Access Compliance Report

Public Rights-of-Way

Intersection ID: 43670	Main Street: S_TRYON_ST	Cross Street: CORSICA_FOREST_DR	Location: N
ADA ID: A529491FFB57	Ramp Type: Perp	Initial Pass/Fail: Fail	Overall Compliance: No
Severity Score: 33.75			
Codes/Mitigation Info/Possible Solution		Field Measurements/Component Compliance

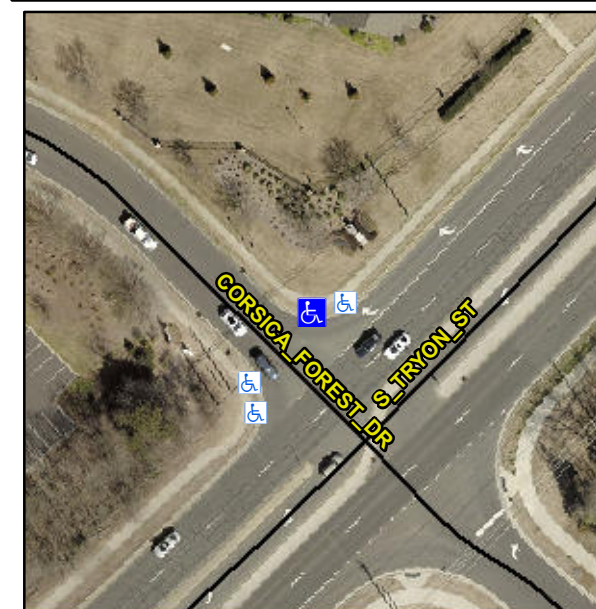
R304.5.1, R304.2.2, R304.5.3

Compliance	Description	Data	Compliance	Description	Data
N/A	Ramp Length (in)	47.0	No	Ramp Slope (%)	9.1
No	Ramp Width (in)	47.5	No	Ramp XSlope (%)	5.7
N/A	Flare Type LT	N/A	N/A	Flare Type RT	N/A
N/A	Flare Slope LT (%)	N/A	N/A	Flare Slope RT (%)	N/A
N/A	Flare Traversable LT?	N/A	N/A	Flare Traversable RT?	N/A
N/A	Landing Length (in)	N/A	N/A	DWS Provided?	N/A
N/A	Landing Width (in)	N/A	N/A	DWS Contrast?	N/A
N/A	Landing Slope (%)	N/A	N/A	DWS Length (in)	N/A
N/A	Landing X Slope (%)	N/A	N/A	DWS Full Width?	N/A
N/A	Landing Curb? (Y/N)	N/A	N/A	DWS Offset (in)	N/A
N/A	Shared Landing?	N/A			
N/A	Gutter Ponding?	N/A	N/A	Gutter Slope (%)	N/A
N/A	Gutter Lip Ht (in)	N/A	N/A	Gutter X Slope (%)	N/A
N/A	Painted X Walk1?	No	N/A	Painted X Walk2?	N/A
	X Walk 1 Direction	To SW		X Walk 2 Direction	N/A
N/A	X Walk 1 Width (in)	N/A	N/A	X Walk 2 Width (in)	N/A
	X Walk 1 Slope (%)	0.3		X Walk 2 Slope (%)	N/A
	X Walk 1 X Slope (%)	5.4		X Walk 2 X Slope (%)	N/A

Remove & Replace Entire Ramp.
